**City of Portland, Maine - Building or Use Permit Application**

Permit No: 07-1066	Issue Date:	CBL: 045 E055001
-----------------------	-------------	---------------------

RE: 88A (Rear) Winter Street – 045 E055 – R-6 – enclosing screened porch – permit #  
07-1066

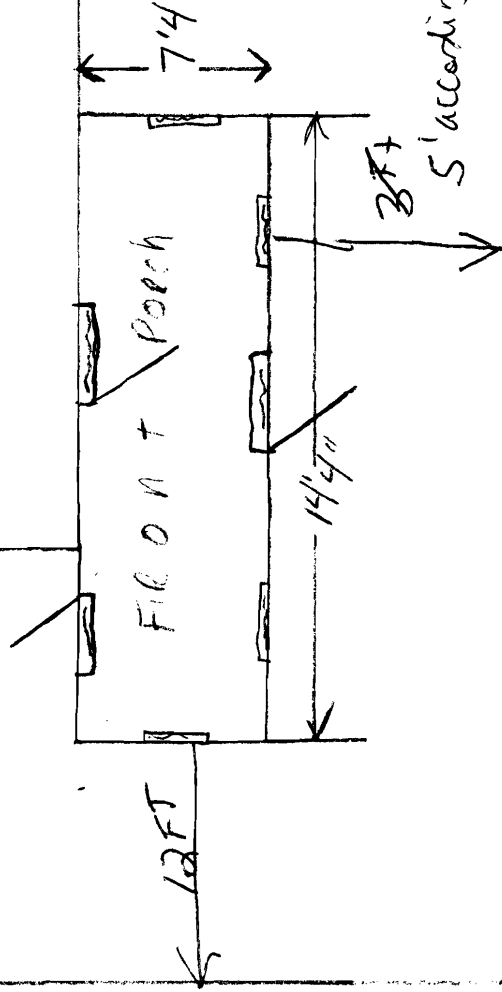
RL  
 lot size 2204  
 front 10' - 3' 5" given  
 side 10' - 10' 5" given  
 lot coverage 50% 1102 sq ft

5' according to conversation w/ Mr. Morris 9/20/07.

NOTES ON THE PORCH AT 88A WINTER STREET

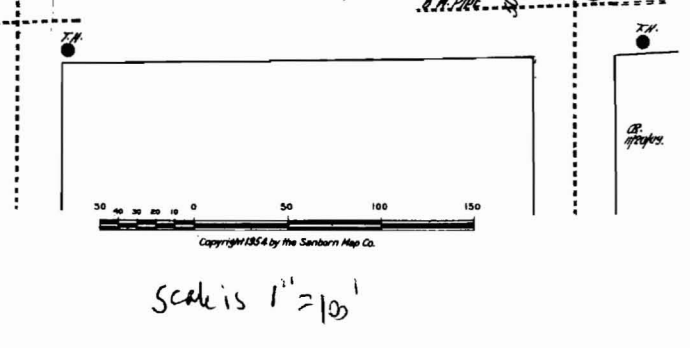
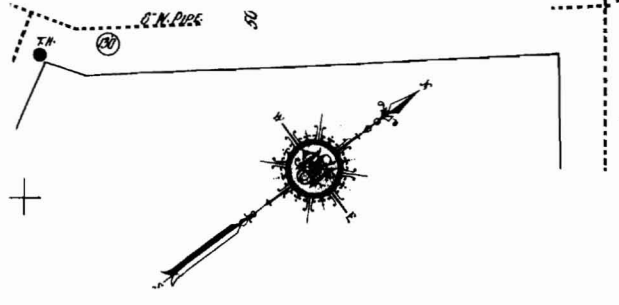
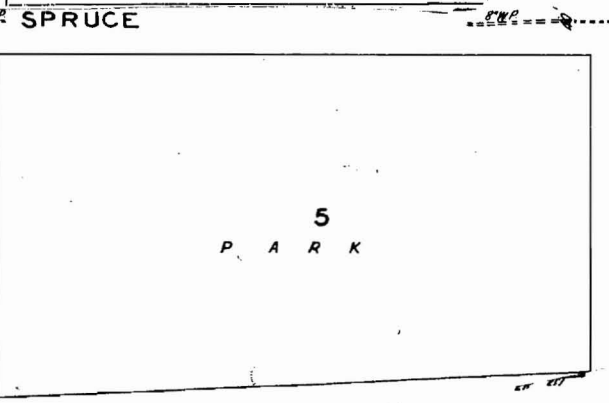
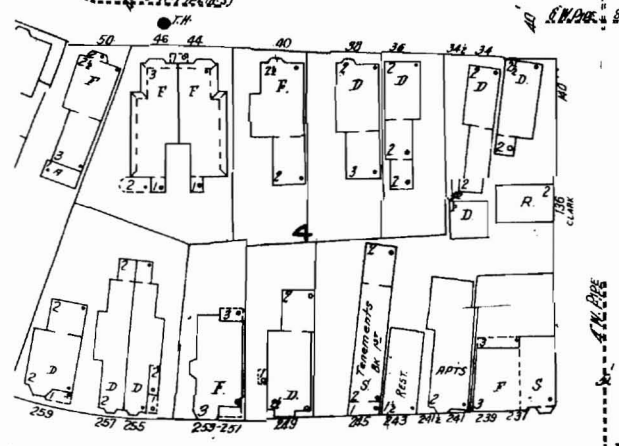
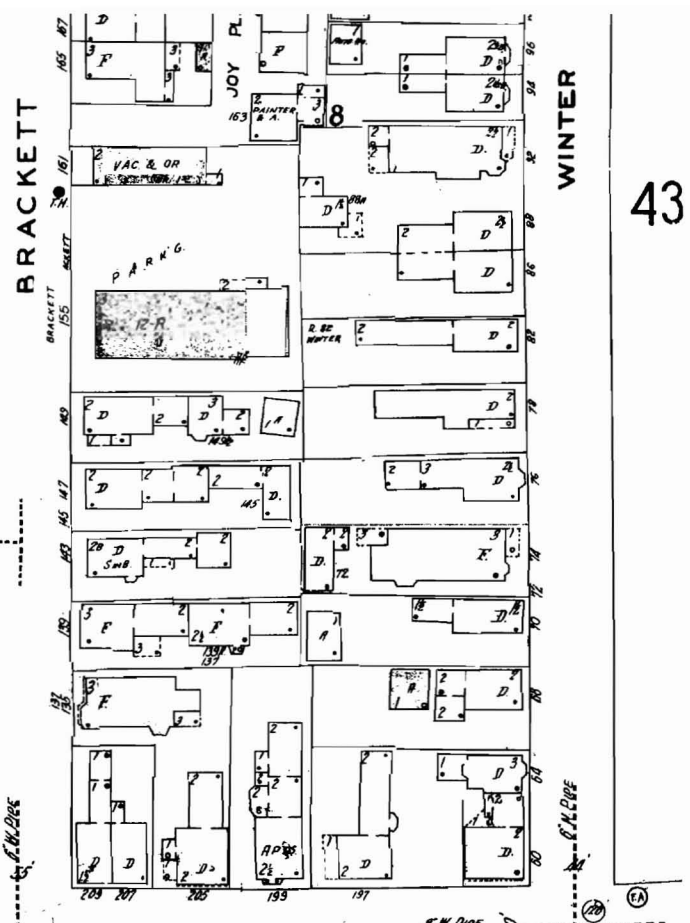
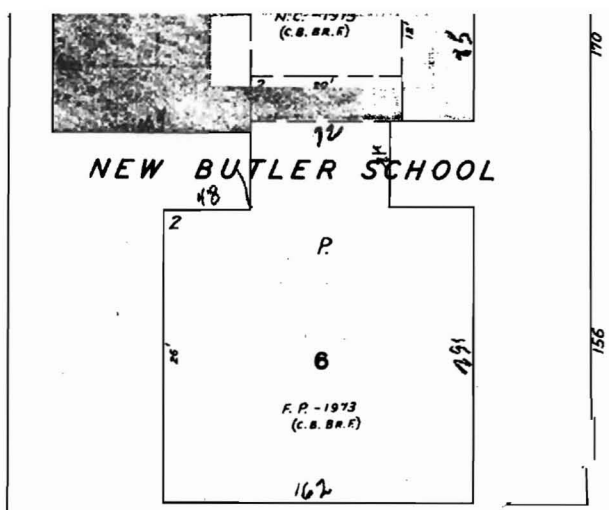
The problem is to make the front of the porch look like a porch and conform architecturally with the rest of the house. To that end Scott suggested the following:

1. The front storm door should match the inside French entry door.
2. Enlarge the two front windows by making them longer and making them a combined double unit.
3. The windows should have a half screen.
4. The windows should be two over two--not multi-paned.

APPROVED BY H.P.
